# UNITED STATES PATENT AND TRADEMARK OFFICE

APPLICATION NO.	FILING DATE	FIRST NAMED INVENTOR	ATTORNEY DOCKET NO.	CONFIRMATION NO.
10/661,549	09/15/2003	Takayuki Nagata		9048
23364	7590	08/18/2005		
BACON & THOMAS, PLLC			EXAMINER	
625 SLATERS LANE			ZARROLI, MICHAEL C	
FOURTH FLOOR				
ALEXANDRIA, VA 22314			ART UNIT	PAPER NUMBER
			2839

<b>Office Action Summary</b>	<b>Application No.</b>	<b>Applicant(s)</b>
	10/661,549	NAGATA, TAKAYUKI
	Examiner Michael C. Zarroli	Art Unit 2839

## **DETAILED ACTION**

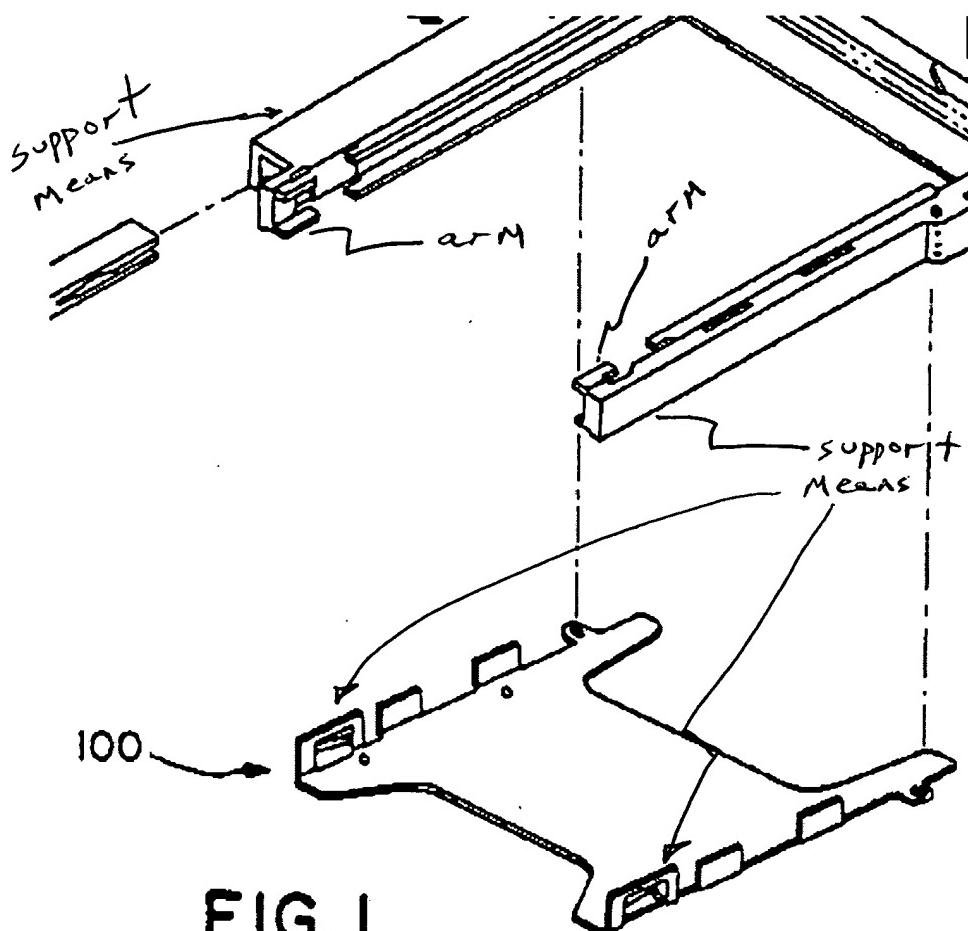
McHugh discloses a card connector (title) comprising: a body (12) made of an integral molded product of a synthetic resin (col. 11 lines 10-15), said body including a head portion and a pair of arms (unnumbered fig. 2) which extend outwardly from said head portion (fig. 14A top, fig. 14C right), each arm of said pair of arms including a foremost end portion (e.g. fig. 1 unnumbered, each arm has an end) a plurality of multipolar contacts (120, 126); and a sheet metal frame (100) which extends between said pair of arms (fig. 1), and which cooperates with said body to form a card insertion space (fig. 14A), wherein: said sheet metal frame including arm support means (see figure below) for blocking inward deflections of said foremost end portions said arm support means is configured by a receiving piece (108, 109, 110) which butts against an inward engagement face that is provided in a foremost end portion of one of said arms (fig. 4 between 97 & 99), said arm-supporting means (see fig. below) is extended in a thickness direction (fig. 14D 72 down) of a card C (not shown) which is to be inserted into said card insertion space, and a lateral width W of a insertion slot (fig. 15A

between arms) of said card insertion space is defined by a distance between opposing inward faces of said receiving pieces (fig. below, arrows).

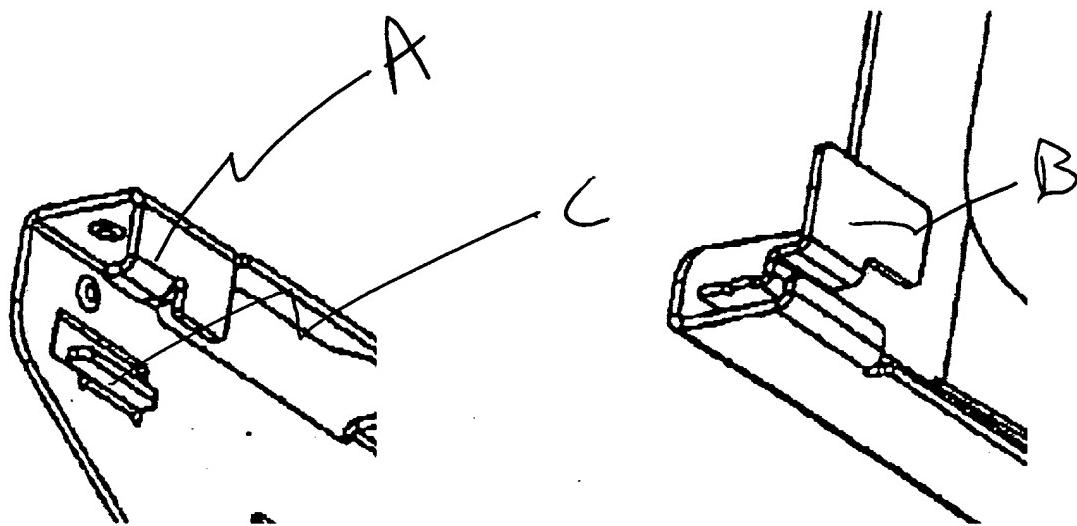
Chang discloses a card connector (title) comprising: a body (2) made of an integral molded product of a synthetic resin said body including a head portion (20), and a pair of arms (22, 24) which extend outwardly from said head portion (fig. 1) each arm of said pair of arms including a foremost end portion (also at 22, 24 in fig. 1) a plurality of multipolar contacts (34); and a sheet metal frame (5) which extends between said pair of arms (fig. 2), and which cooperates with said body to form a card insertion space (200), wherein: said sheet metal frame including arm support means (528, 548) for blocking inward deflections of said foremost end portions (in fig. 3 foremost ends are prevented from deflecting by sheet metal frame arm support means), said arm support means is configured by a receiving piece (528, 522, 542, 548) which butts against an inward engagement face that is provided in a foremost end portion of one of said arms (figures 1 & 3) said arm-supporting means is extended in a thickness direction (fig. 1 at 521 & 541) of a card C (104) which is to be inserted into said card insertion space (fig. 10), and a lateral width W of a insertion slot (fig. 2 between arms) of said card insertion space is defined by a distance between opposing inward faces of said receiving pieces.
